# Value Engineering Study Report I-70 Arriba

Colorado Department of Transportation  
District 4  
I-70 Arriba to Flagler, Colorado

September 2017  
Study Dates: Sept 26 – Sept 28, 2017

<b>COLORADO</b> DEPARTMENT OF TRANSPORTATION	<b>VE RECOMMENDATION</b>	<b>Proposal No. VE-#12</b>
	<b>Project: I-70 Arriba: East and West CDOT</b>

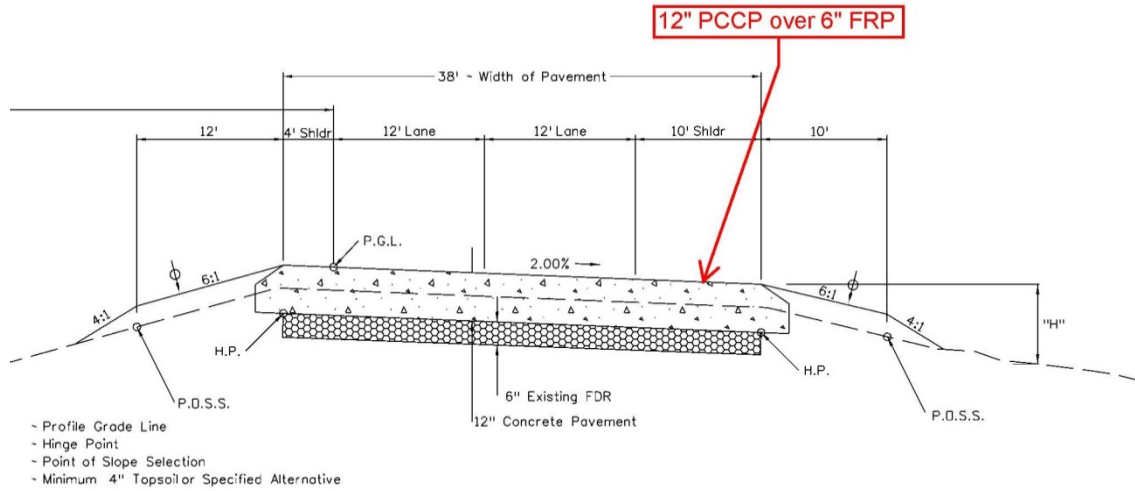
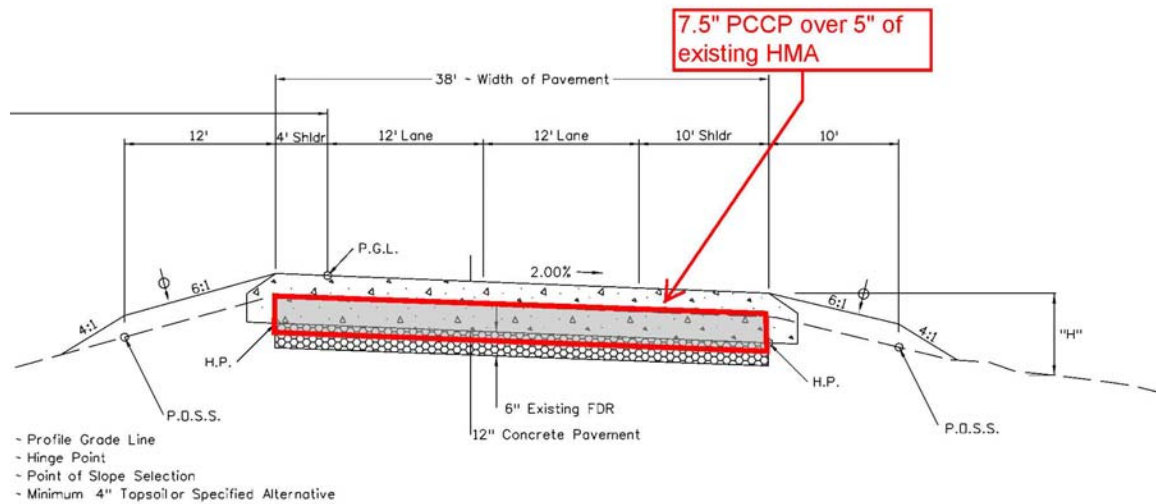
Mill 7-inches of the existing pavement followed by placement of 7.5-inches of bonded concrete pavement (see attached white topping design calculation). The old HMA pavement will be milled to remove the top 7 inches, including the petromat, and leave 5” of exiting HMA.

1. The smaller panel sizes will result more joint maintenance than a standard pavement
2. The pavement will be more susceptible to faulting because there is not load transfer in the transverse joints
3. Based on the core from previous testing, the condition of the lower lifts of existing HMA is suspect and from discussion with local CDOT personnel (maintenance personnel) have also encountered problems with performance of portions of the east bound lanes.

The VE Team does not recommend this Alternative. Based upon the questionable core samples and discussion with CDOT staff, the existing lower lifts of HMA may not be stable enough, and may create more maintenance issues and pavement failure in the future.

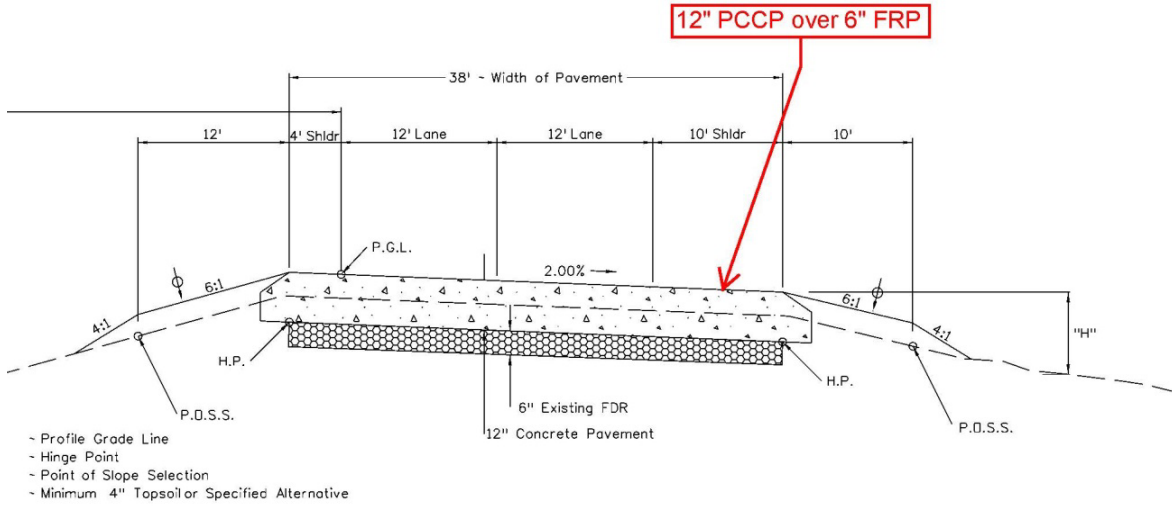
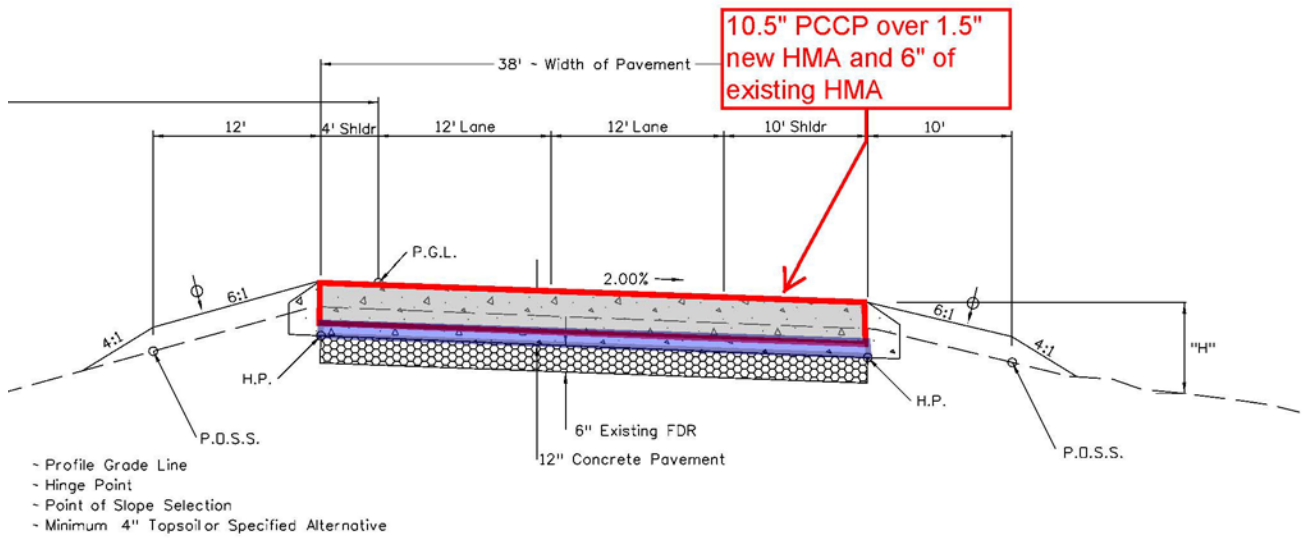
For the east bound lanes, as was done on the PCCP project immediately east of Flagler, the pavement could be milled to remove 6 inches of existing HMA. Following milling the existing HMA would be overlaid with a 1.5-inch layer of HMA to prevent bonding to the old HMA, and then a 10.5-inch PCCP pavement section could be placed for the final surface.

1. The bond breaking overlay will require an additional HMA layer and will add cost, also it require an additional subcontractor and operation on the project.

The VE Team does not recommend this Alternative. This alternative is not recommended because of the questionable condition of the lower asphalt layers.
